CALIFORNIA COASTAL COMMISSION

A-5-LGB-22-0009 (Gross)

APRIL 21, 2022

2475 South Coast Highway Art Installation
2475 South Coast Highway
Laguna Beach California 92651

ART INSTALLATION PLAN

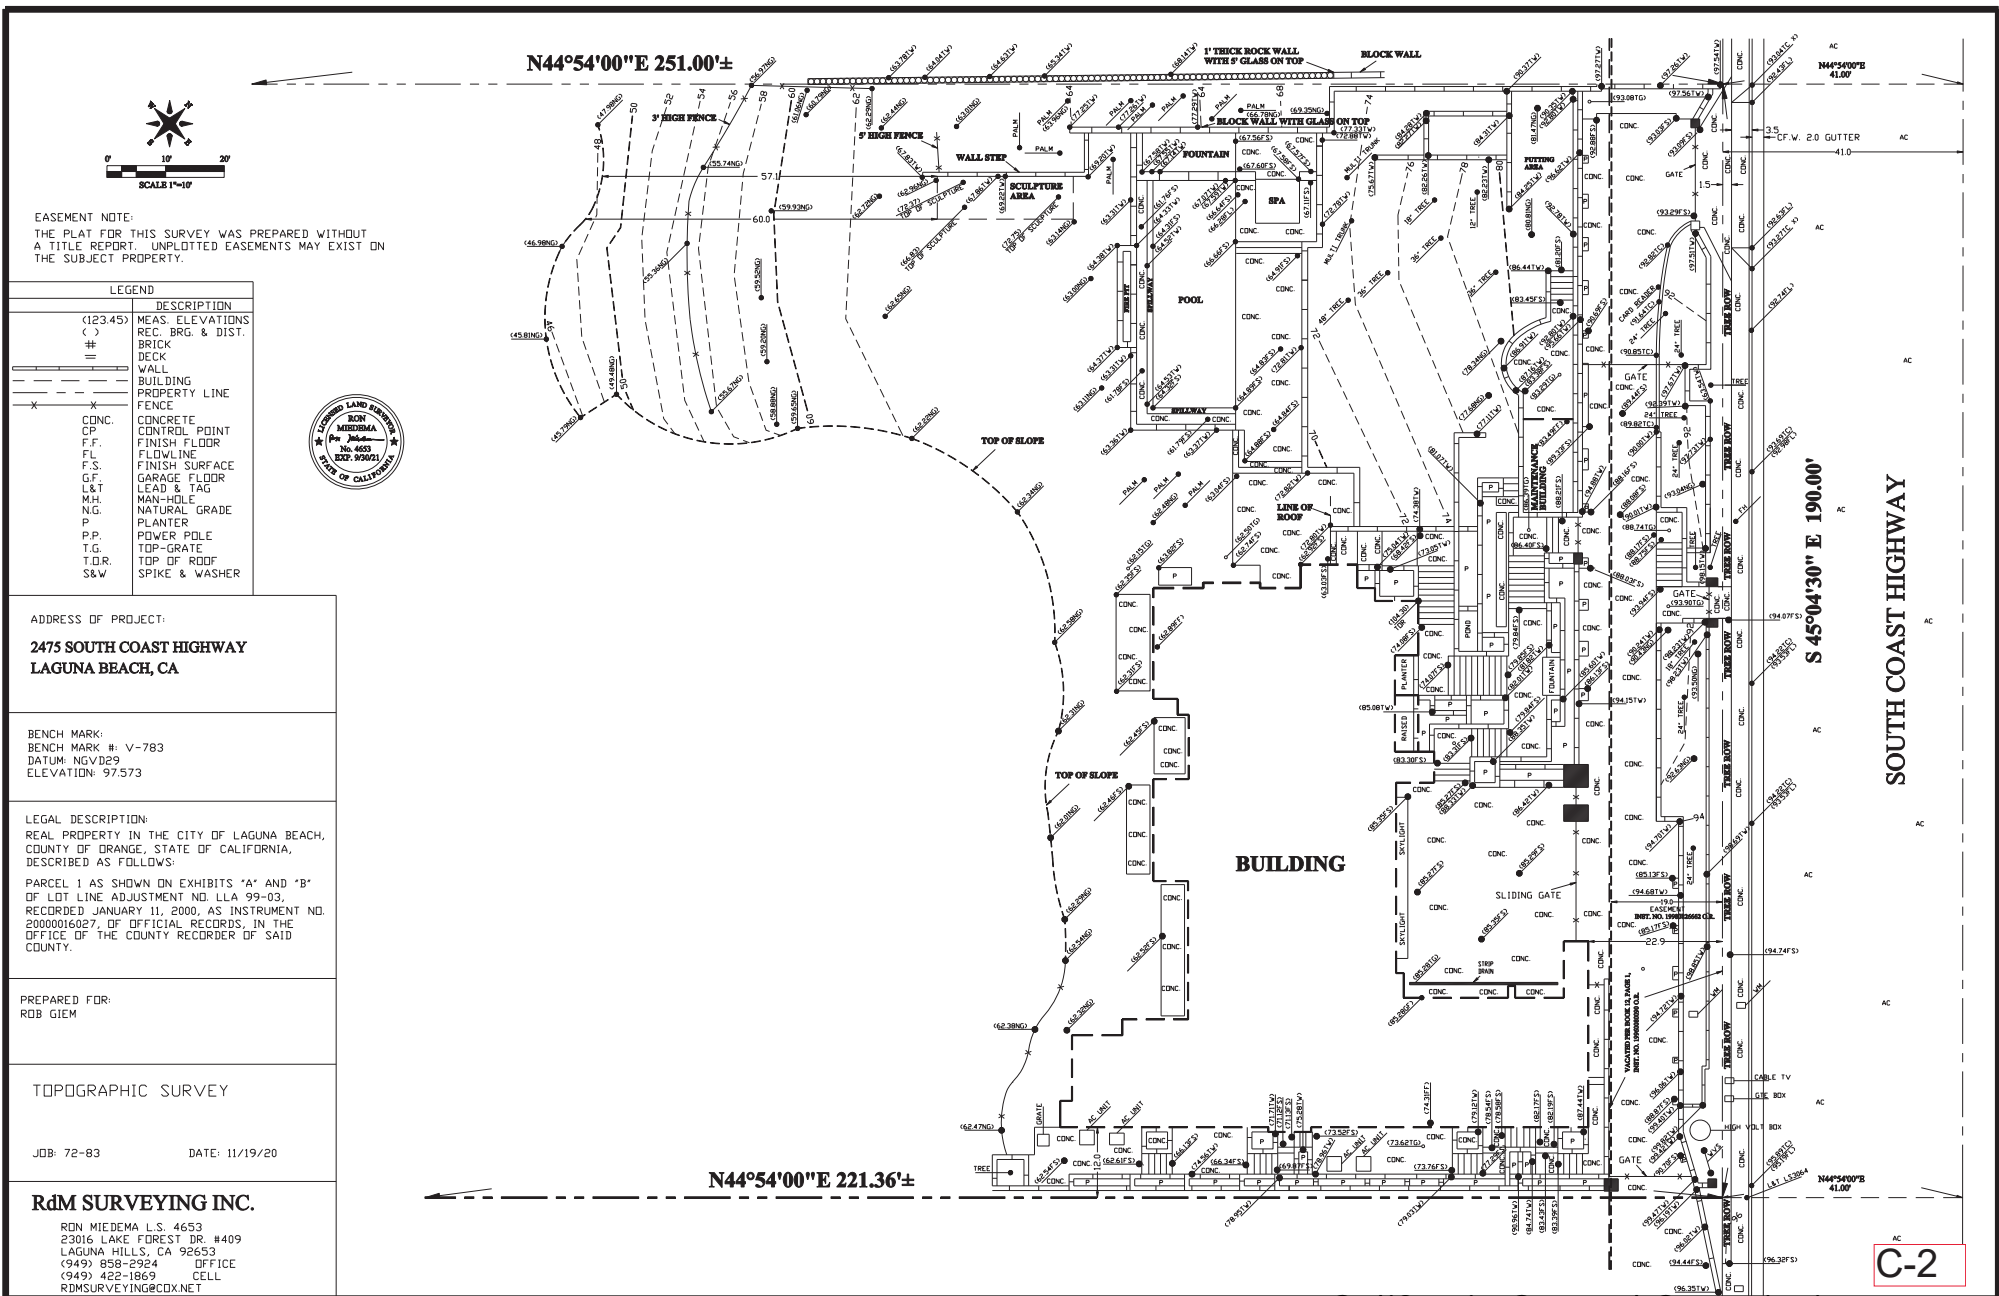
As submitted to the Board, the Applicants' plans depict an inaccurate stringline, which is actually further inland than the depicted 25' bluff top setback. (See Exhibit G to Comment Letter [depiction of actual stringline imposed on Applicants' plans, prepared by architect Morris Skenderian].) The Project plans depict the stringline at the adjacent property Villa Rockledge as emanating from a certain point on the main house. However, there is another portion of the building adjacent to and closer to Villa Rockledge near the property line and, therefore, that portion or corner of the building should be used to calculate the stringline rather than the main house. Utilizing the correct portion of the building, the new stringline would be approximately 3'-4' closer to the Project as depicted in the plans and, as shown in Exhibit G, the Project would exceed that required setback

Here, the applicants' plans depict an inaccurate stringline, which is actually further inland than the depicted 25' bluff top setback. (See Exhibit G [depiction of actual stringline imposed on applicant's plans, prepared by architect Morris Skenderian].) The Project plans depict the stringline at Villa Rockledge as emanating from a certain point on the main house. However, there is another portion of the building adjacent to and closer to Villa Rockledge near the property line and, therefore, that portion or corner of the building should be used to calculate the stringline rather than the main house. Utilizing the correct portion of the building, the new stringline would be approximately 3'-4' closer to the Project as depicted in the plans and, as shown in Exhibit G, the Project would exceed that required setback.⁴

⁴ There are actually two stringlines depicted on the applicants' plan: (1) approximate patio stringline, and (2) approximate building stringline. They are labeled incorrectly, and their labels should be switched.
